Date: June 22, 2005
Refer to: ER2005-0407

SUBJECT: RESPONSE TO THE NOTICE OF "APPROVAL WITH MODIFICATIONS INVESTIGATION WORK PLAN FOR MATERIAL DISPOSAL AREA T SOLID WASTE MANAGEMENT UNIT 21-016(a)-99"

**Response to
Approval with Modifications,
Investigation Work Plan for Material Disposal Area T,
Solid Waste Management Unit 21-016(a)-99,
Los Alamos National Laboratory,
EPA ID #NM0890010515 HWB-LANL-04-003.
Dated May 19, 2005**

Attachment 2
Planned Borehole Locations at MDA T

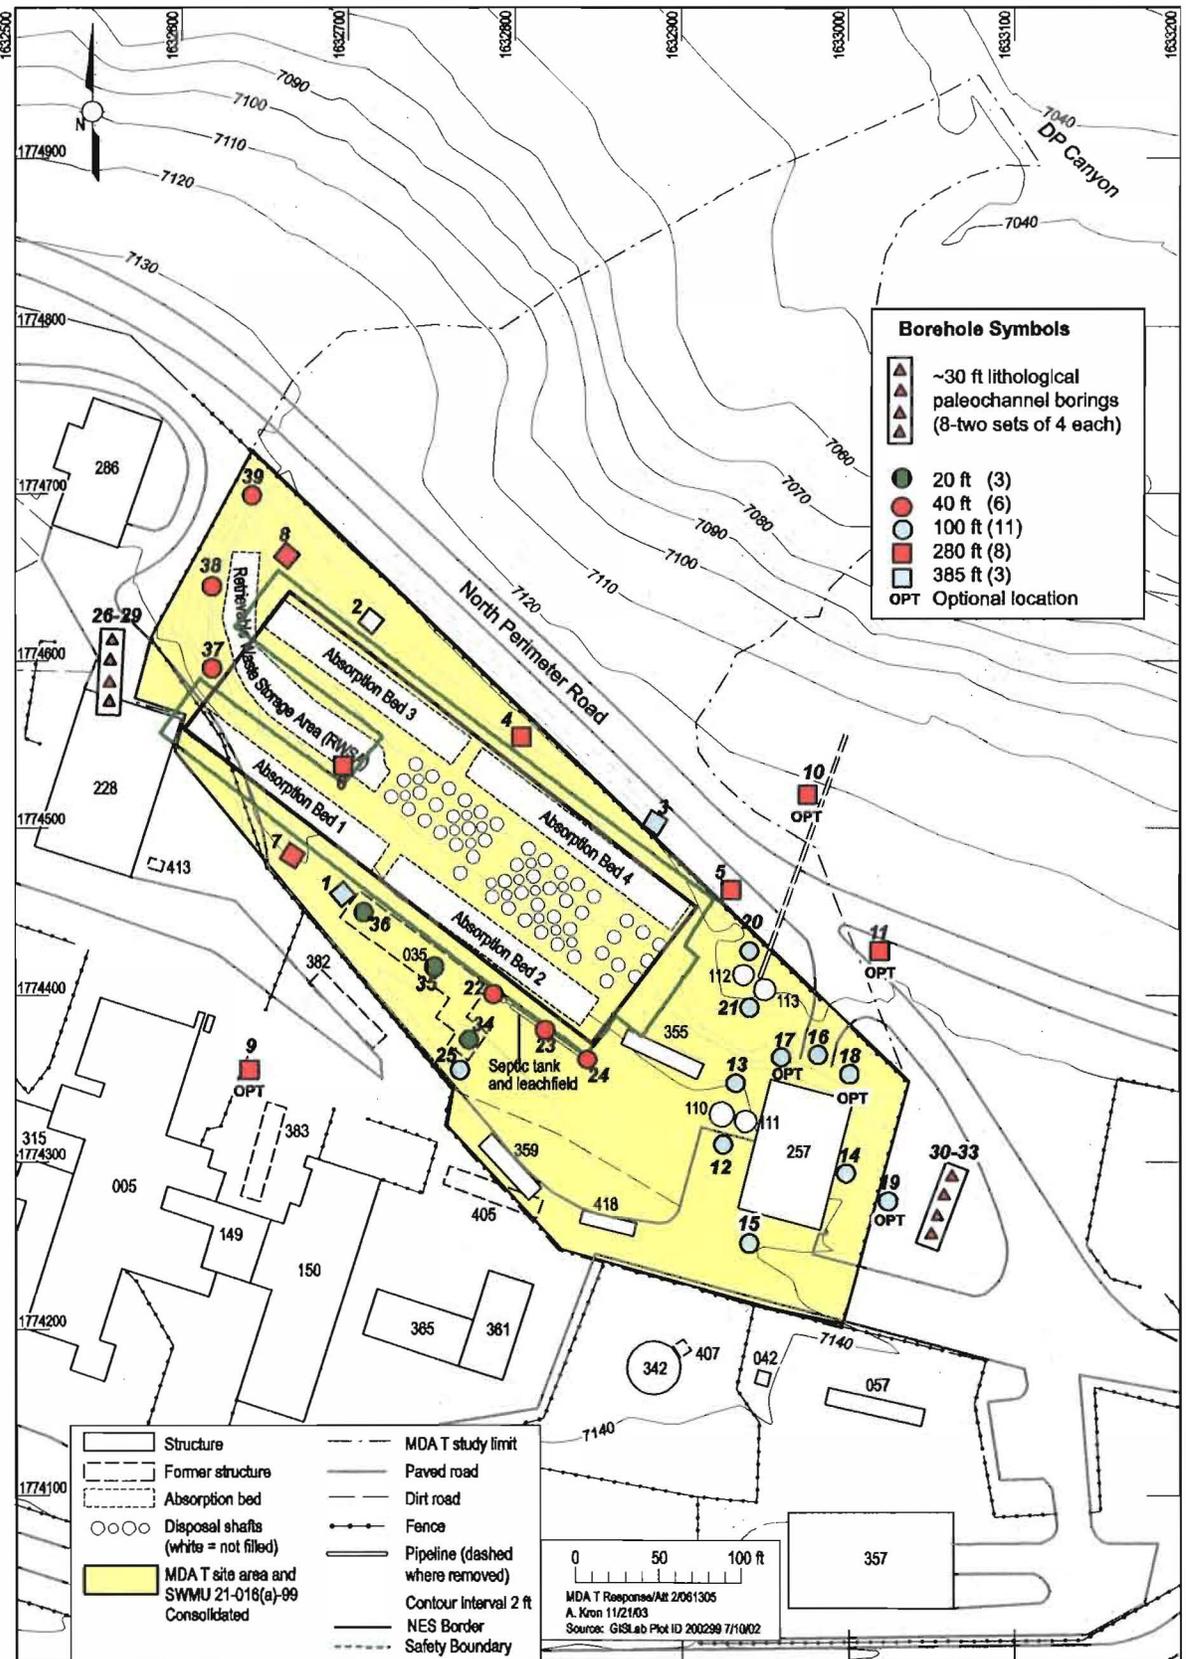
8. **Response Table 1, Summary of Borehole Sample Target and Figure 12 Revised Borehole Locations:**
9. **NMED Comment:** *Boreholes 1-5 shall be moved as close as possible to the absorption beds.*
